Access Compliance Report

Public Rights-of-Way

(Curb Ramps)

Intersection ID: 46320	Main Street: SHAD_CT	Cross Street: BREWER_DR	Location: NW
ADA ID: 6B317D2114D2	Ramp Type: Perp	Initial Pass/Fail: Fail	Overall Compliance: No
Severity Score: 10			
Codes/Mitigation Info/Possible Solution		Field Measurements/Component Compliance

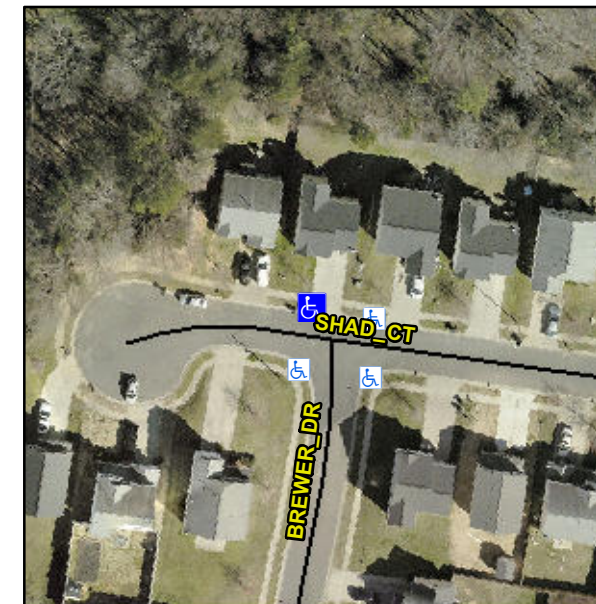
Not Found, R304.5.1, R304.5.3

Compliance	Description	Data	Compliance	Description	Data
N/A	Ramp Length (in)	49.0	Yes	Ramp Slope (%)	6.2
No	Ramp Width (in)	47.5	No	Ramp XSlope (%)	4.8
N/A	Flare Type LT	N/A	N/A	Flare Type RT	N/A
N/A	Flare Slope LT (%)	N/A	N/A	Flare Slope RT (%)	N/A
N/A	Flare Traversable LT?	N/A	N/A	Flare Traversable RT?	N/A
N/A	Landing Length (in)	N/A	N/A	DWS Provided?	N/A
N/A	Landing Width (in)	N/A	N/A	DWS Contrast?	N/A
N/A	Landing Slope (%)	N/A	N/A	DWS Length (in)	N/A
N/A	Landing X Slope (%)	N/A	N/A	DWS Full Width?	N/A
N/A	Landing Curb? (Y/N)	N/A	N/A	DWS Offset (in)	N/A
N/A	Shared Landing?	N/A			
N/A	Gutter Ponding?	N/A	N/A	Gutter Slope (%)	N/A
N/A	Gutter Lip Ht (in)	N/A	N/A	Gutter X Slope (%)	N/A
N/A	Painted X Walk1?	No	N/A	Painted X Walk2?	N/A
	X Walk 1 Direction	To S		X Walk 2 Direction	N/A
N/A	X Walk 1 Width (in)	N/A	N/A	X Walk 2 Width (in)	N/A
	X Walk 1 Slope (%)	1.2		X Walk 2 Slope (%)	N/A
	X Walk 1 X Slope (%)	4.5		X Walk 2 X Slope (%)	N/A

Remove & Replace Entire Ramp.
